Access Compliance Report

Public Rights-of-Way

Intersection ID: 5468	Main Street: N_TRYON_ST	Cross Street: J_W_CLAY_BV	Location:	N
ADA ID: 740CDC1FE181	Ramp Type: Perp	Initial Pass/Fail: Fail	Overall Compliance: No	Severity Score: 10

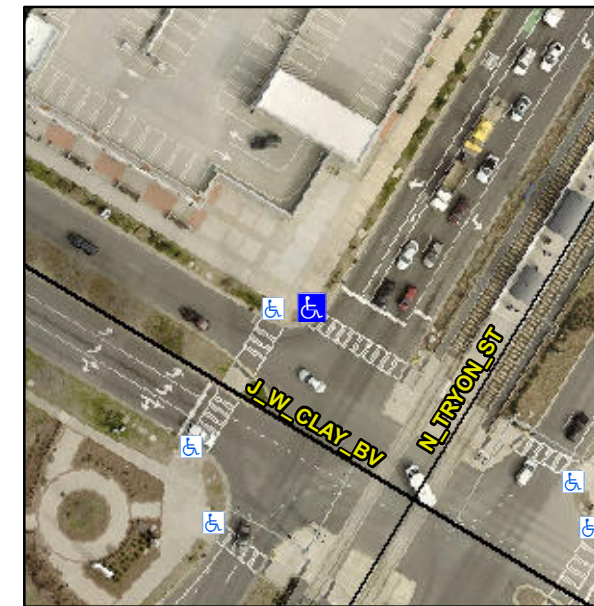
R304.5.1

Compliance	Description	Data	Compliance	Description	Data
N/A	Ramp Length (in)	73.0	Yes	Ramp Slope (%)	6.3
No	Ramp Width (in)	46.5	Yes	Ramp XSlope (%)	2.1
N/A	Flare Type LT	N/A	N/A	Flare Type RT	N/A
N/A	Flare Slope LT (%)	N/A	N/A	Flare Slope RT (%)	N/A
N/A	Flare Traversable LT?	N/A	N/A	Flare Traversable RT?	N/A
N/A	Landing Length (in)	N/A	N/A	DWS Provided?	N/A
N/A	Landing Width (in)	N/A	N/A	DWS Contrast?	N/A
N/A	Landing Slope (%)	N/A	N/A	DWS Length (in)	N/A
N/A	Landing X Slope (%)	N/A	N/A	DWS Full Width?	N/A
N/A	Landing Curb? (Y/N)	N/A	N/A	DWS Offset (in)	N/A
N/A	Shared Landing?	N/A			
N/A	Gutter Ponding?	N/A	N/A	Gutter Slope (%)	N/A
N/A	Gutter Lip Ht (in)	1.5	N/A	Gutter X Slope (%)	N/A
N/A	Painted X Walk1?	No	N/A	Painted X Walk2?	N/A
	X Walk 1 Direction	To SE		X Walk 2 Direction	N/A
N/A	X Walk 1 Width (in)	N/A	N/A	X Walk 2 Width (in)	N/A
	X Walk 1 Slope (%)	4.0		X Walk 2 Slope (%)	N/A
	X Walk 1 X Slope (%)	2.9		X Walk 2 X Slope (%)	N/A

Remove & Replace Entire Ramp.
